**THE
NATIONAL
BOARD**
OF BOILER AND
PRESSURE VESSEL
INSPECTORS

NATIONAL BOARD SUBCOMMITTEE INSPECTION

AGENDA

Meeting of October 19th, 2020
WebEx Online Meeting

FIGURE S10.10.5
SENSOR SPACING AND PATTERN

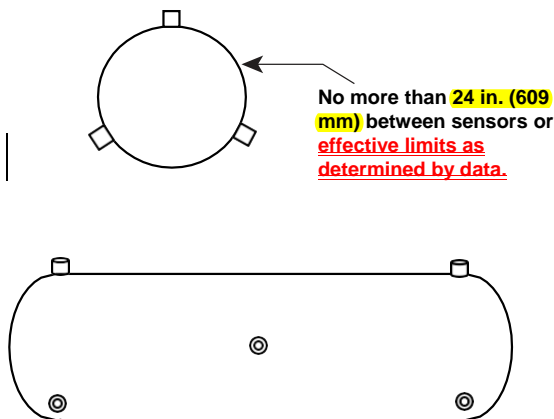
Item Number: PR20-0202	NBIC Location: Part 2, S10.10.5	Attachment Page 4
Submitted by: Alexander Garbolevsky, Hartford Steam Boiler		
Related NBIC Action Item: Item NB16-1401 (Revise and update Supplement 10 on Inspection of CRPVs)		
Comment: “24 in.” appears twice as 610 mm and once as 609 mm in both the text and in the accompanying Figure.

Item 16-1401, Part 2, S10.10.5 - "24 in." appears twice as 610 mm and once as 609 mm in both the text and in the accompanying Figure.
